PIERGIORGIO BERUTO
ANTONIO ORZELLI

IEEE 802.3cg
PLCA Burst mode fixes

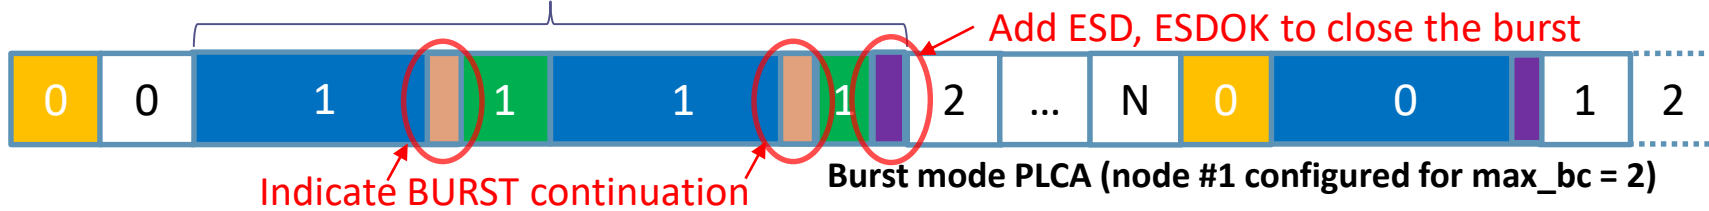
node #1 sends a burst of 2 packets, and needs to append an empty COMMIT

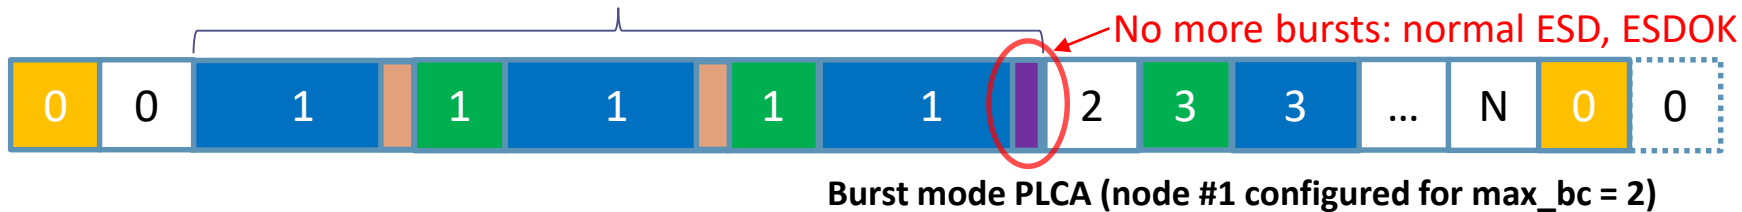
node #1 sends a burst of 3 packets (max) and does not append a COMMIT

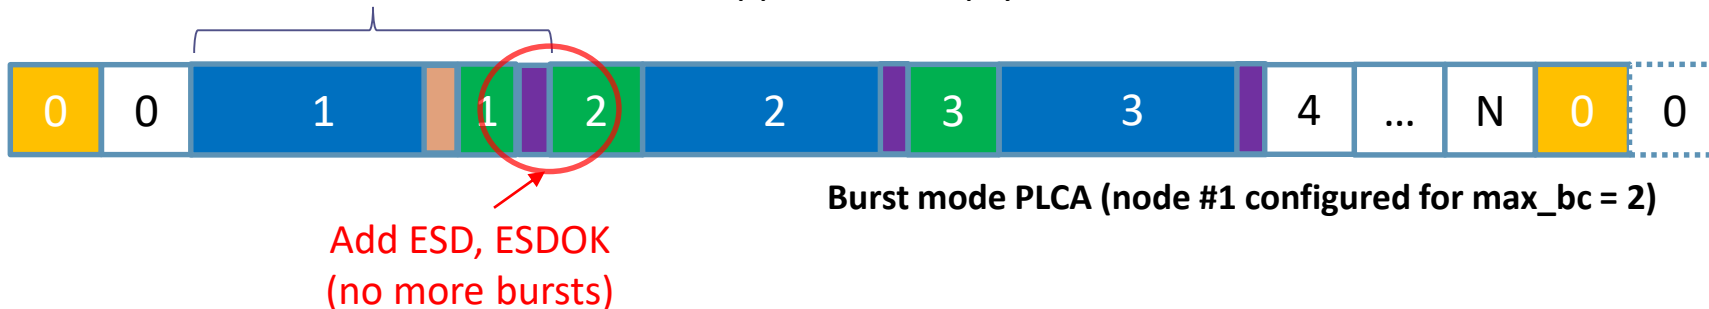
node #1 does not burst but still needs to append an empty COMMIT

Figure 147-4 – PCS Transmit state diagram (part a)

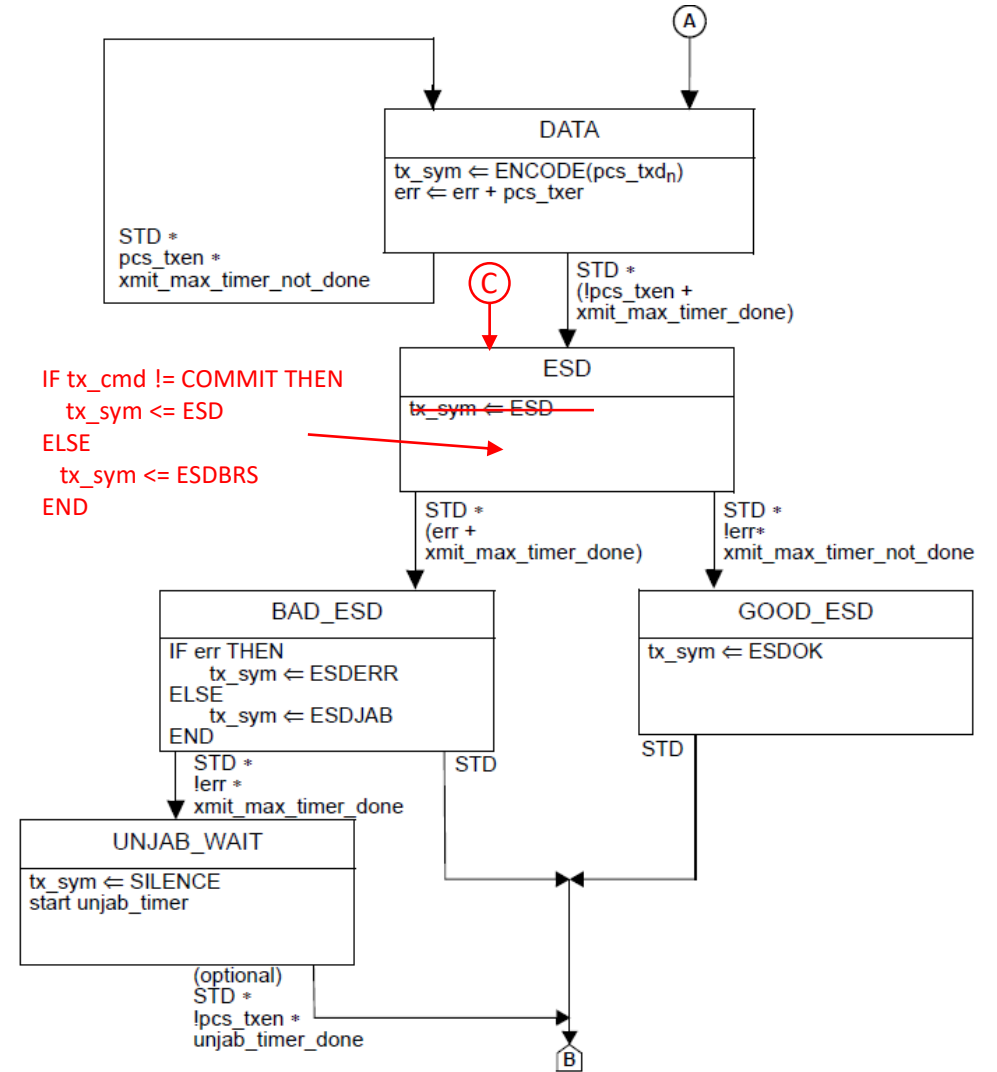
- Use explicit ESD, ESDOK 5B symbol sequence to end a COMMIT request when the MAC has no more packets to send in a burst
 - This also prevents the spurious “FALSE carrier” indication
- Use a different ESD code to terminate a packet when a BURST follows
 - This also simplifies significantly the receiver as ESDOK/ERR is always followed by silence
- Increase minimum DME silence period to guarantee at least one full 5B symbol of silence afterwards
- State diagram fix to Clause 147
 - The number of changes may look significant but the actual *—functional—* modification is very limited
- State diagram fix to Clause 148

PCS TX state diagram changes

Figure 147-7—PCS Receive state diagram (part a)

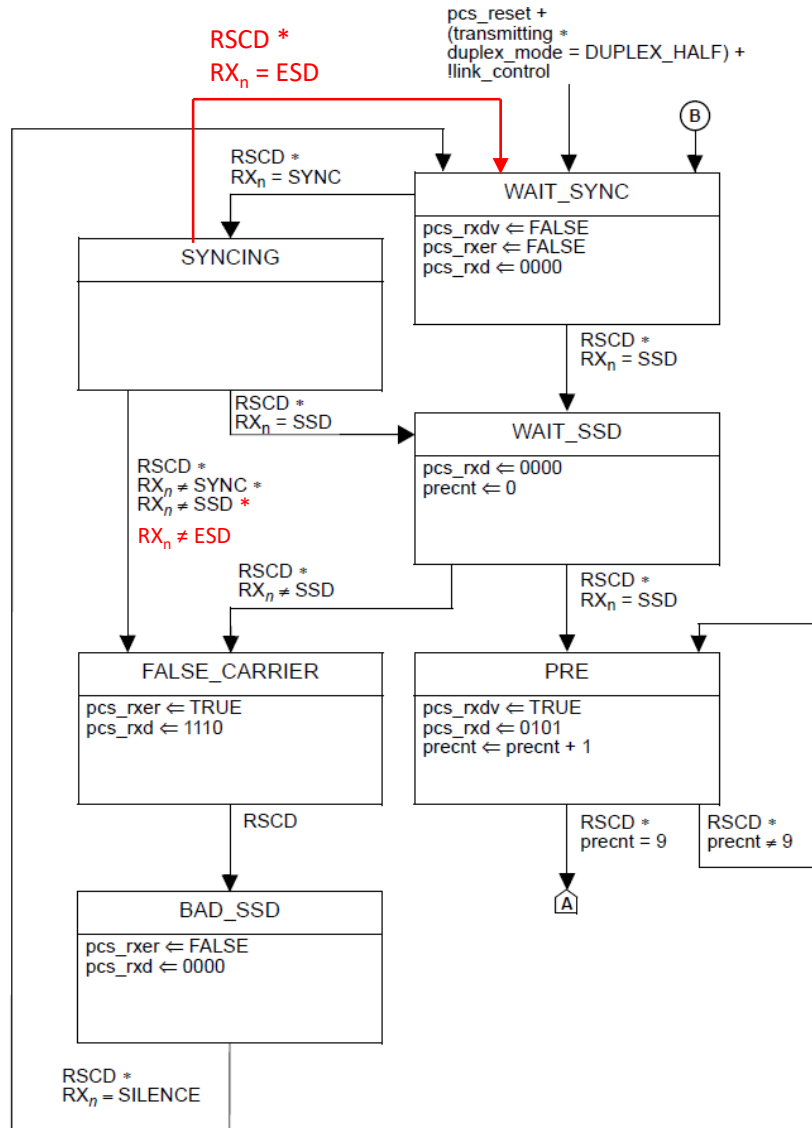
PMA and PCS RX state diagram changes

Figure 148-5—PLCA DATA state diagram

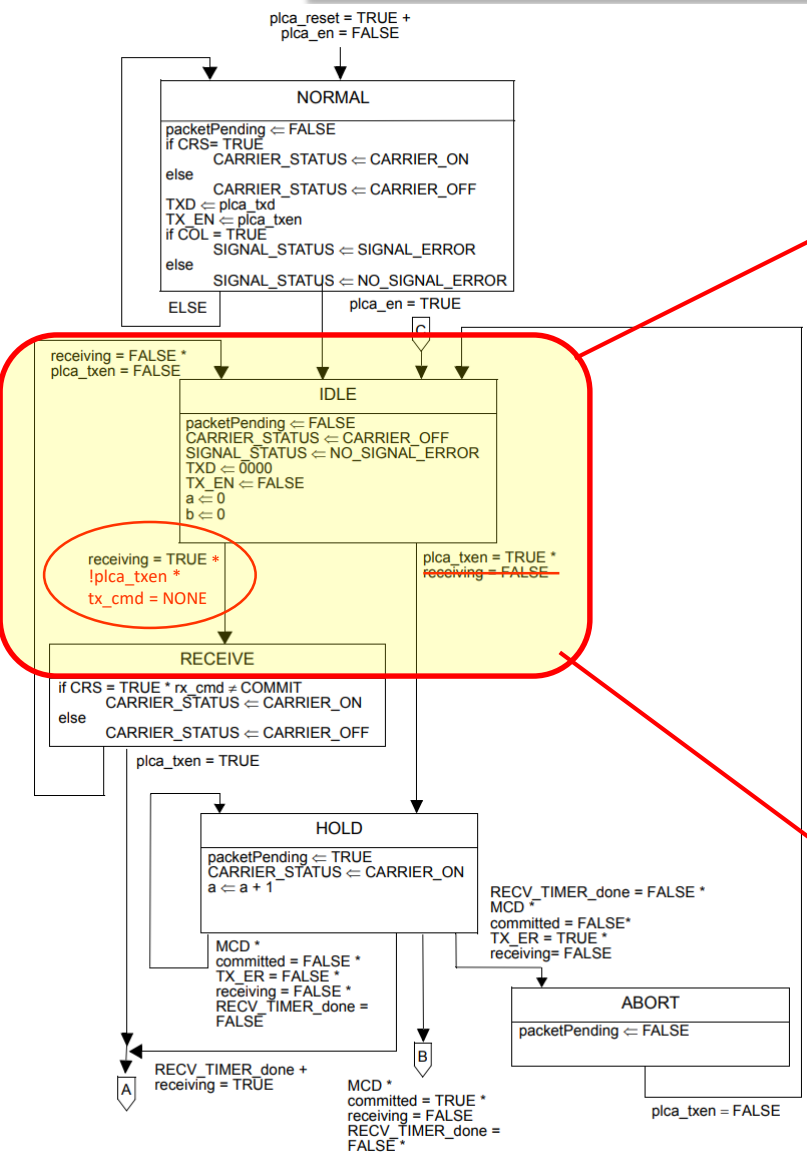
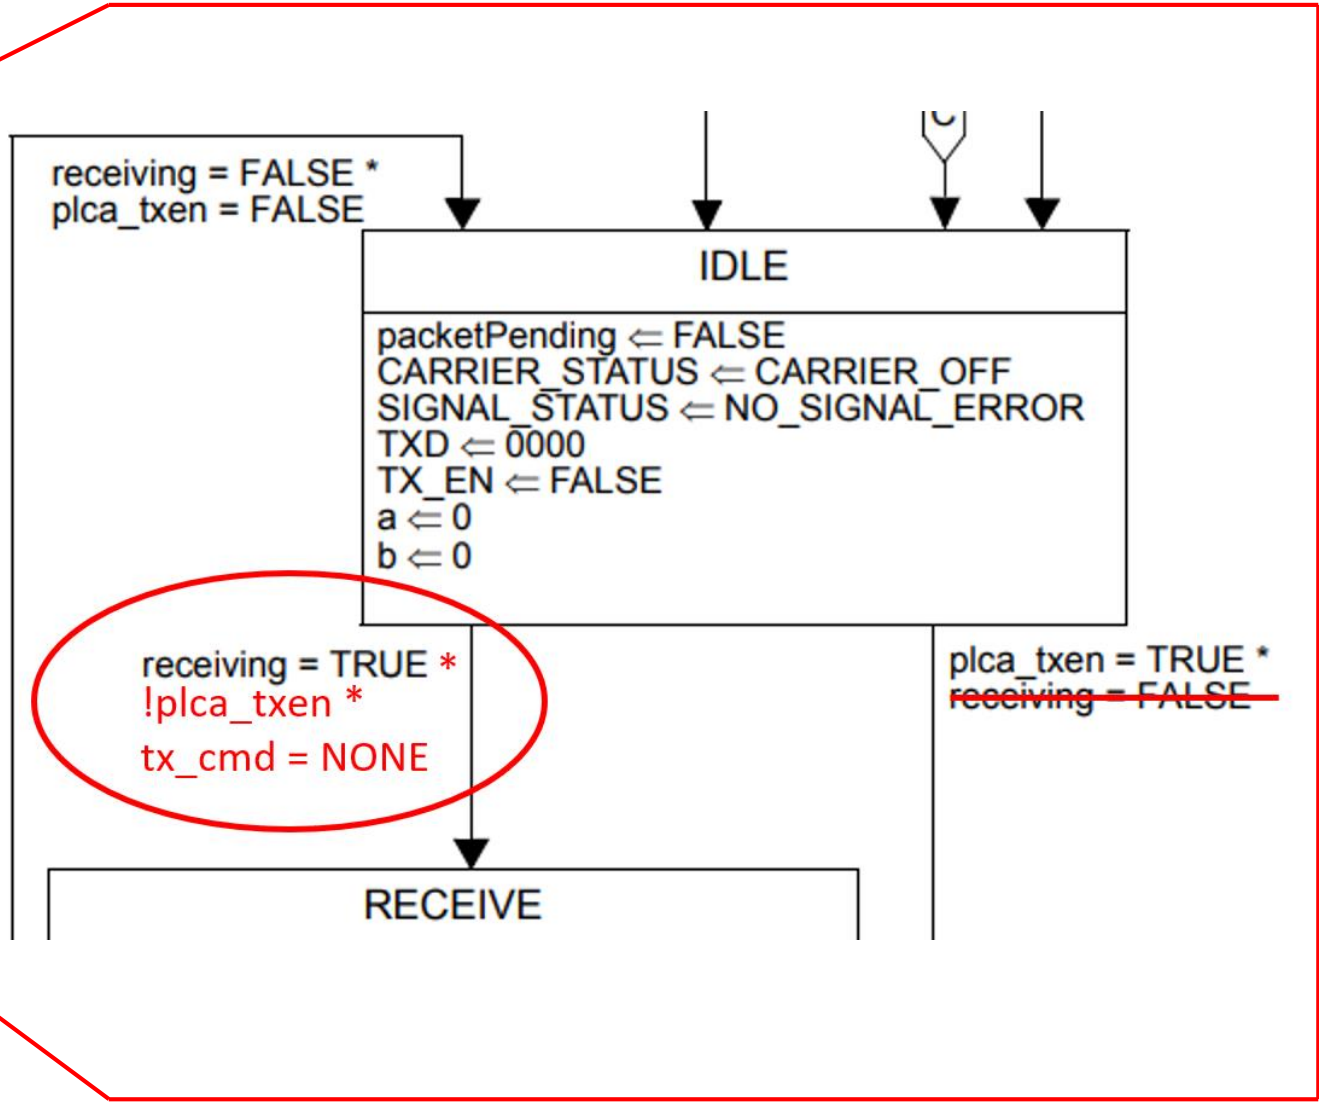
- Again, detecting **silence** (High-Z) is not reliable as detecting a specific code
- Besides, there was one missing change for Clause 148
 - Depending on implementation (internal delays), PLCA DATA State Diagram could detect a false reception when filling the IPG with idle.

PLCA DATA state diagram changes
